## **REMARKS**

**IN THE DRAWINGS:**

Applicants submit Replacement and Annotated Sheets for Figures 4 and 7. Applicants respectfully request that new Figures 4 and 7, submitted herewith be substituted for the originally filed Figures 4 and 7.

FIG. 4

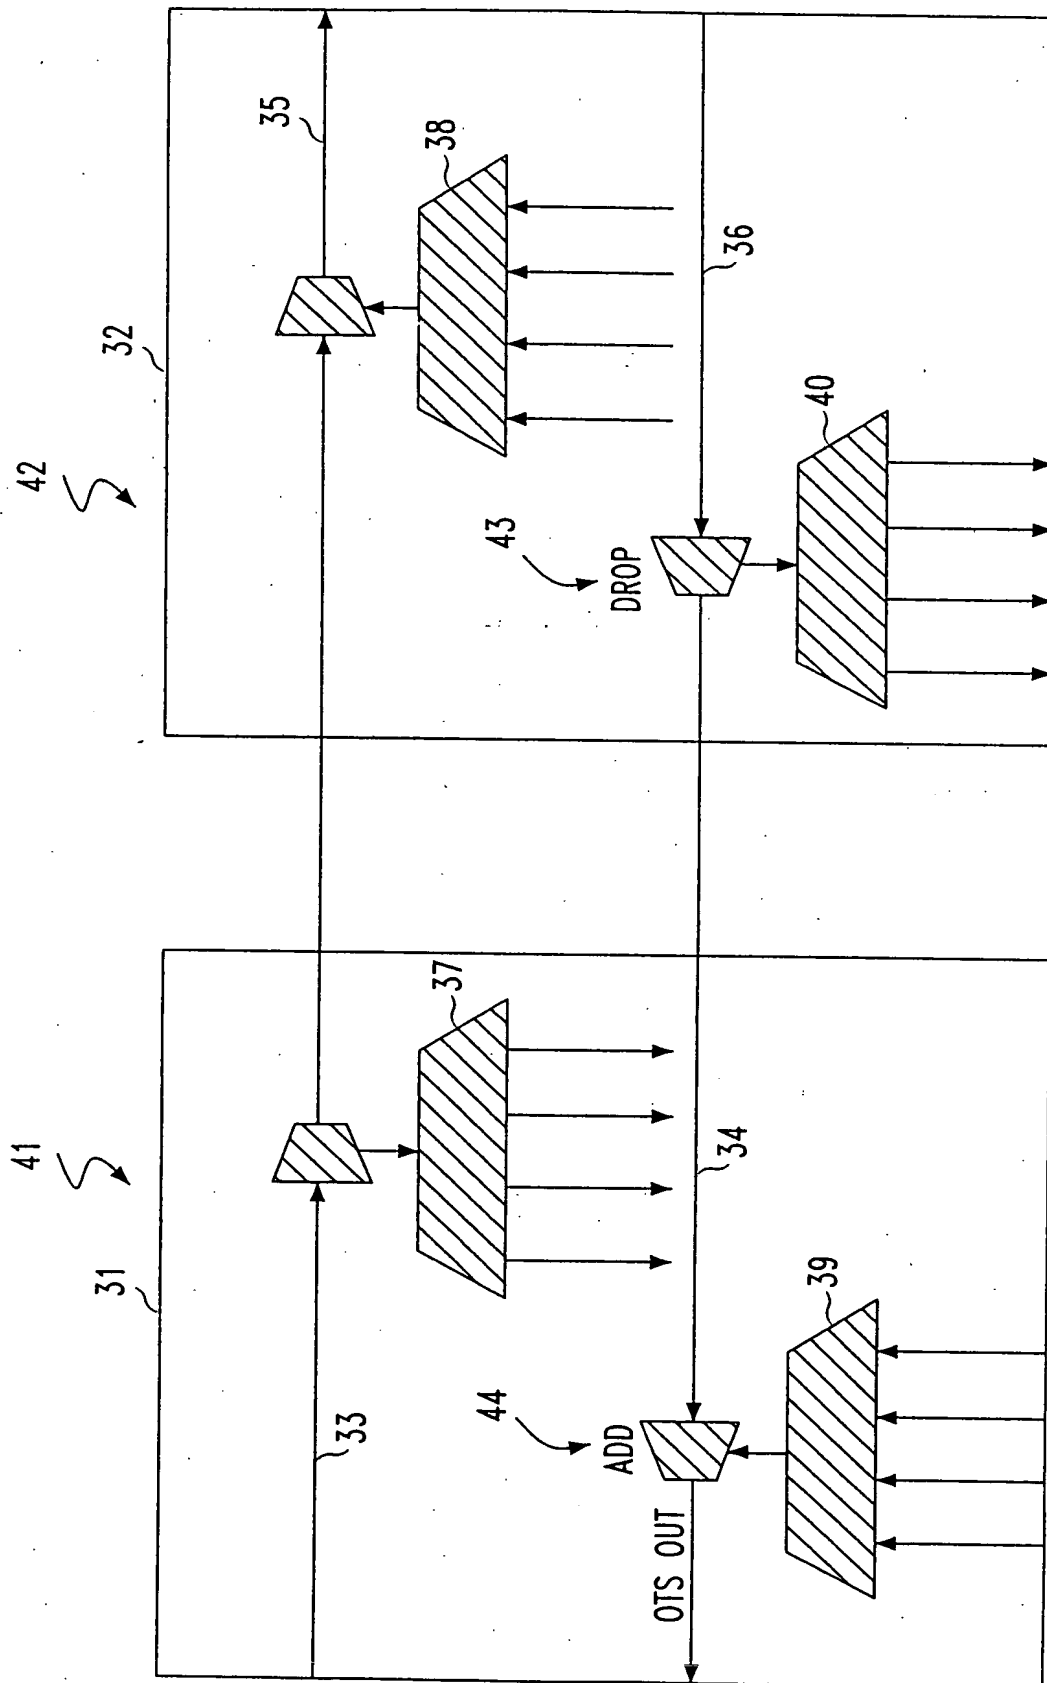
With respect to the drawings, Applicants are taking this opportunity to correct informalities in Figures 4 and 7. In the lower left of Figure 4, “34” is being changed to “30,” which generally identifies the duplex link shown in Figure 4. In Figure 7, “111” is being changed to “110” to identify the bandpass filter.
